Subject BMW Recall 21V-096: Rearview Camera

SIB 66 02 21

RECALL 21V-096: REARVIEW CAMERA

Picture 1.

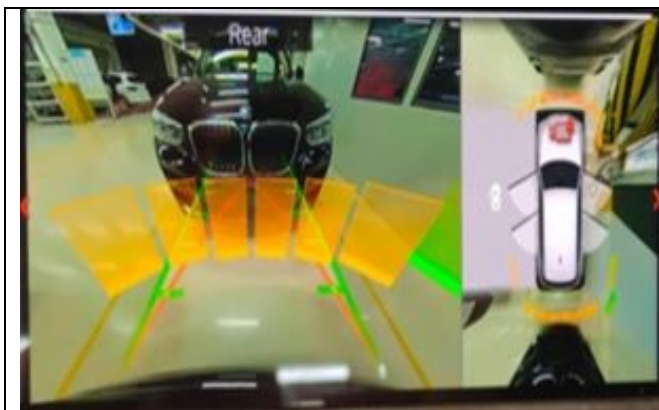
The images are displayed in the **correct image position** on the CID for vehicles equipped with option code 6U3.

Picture 2.

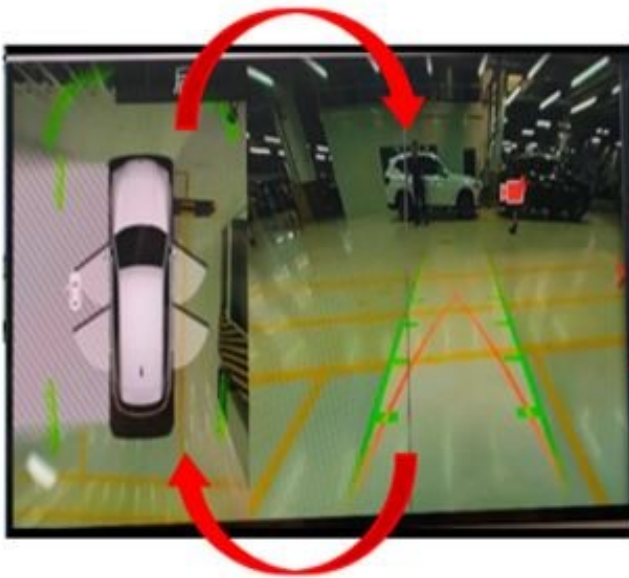
Shows a possible failure in vehicles equipped with option 6U3.

The top view and rearview images are **incorrectly displayed** in the wrong position (swapped) on the CID.

Note: The camera icon is in the correct location, however it seems out of place due to wrong image location.

Encode the ICAM using ISTA 4.27.1x or higher (released December 2020).

4. Connect the vehicle to ISTA 4.27.1x or higher.
5. Start a new programming session, go to Advanced Tab.
6. Select **all** control units for encoding.
7. Calculate and accept measures plan.
8. Once the encoding/programming is completed, follow the rework list.
9. Depending on the rework list, if necessary, perform vehicle test and delete the error memory (faults).
10. Allow the vehicle to sleep for 5 minutes.
11. Reassess the vehicle.
Note: Camera image in the CID must match the picture 1 seen in the situation above.
12. If the image does not match picture 1, then recode the ICAM by repeating steps 5 – 9 above.
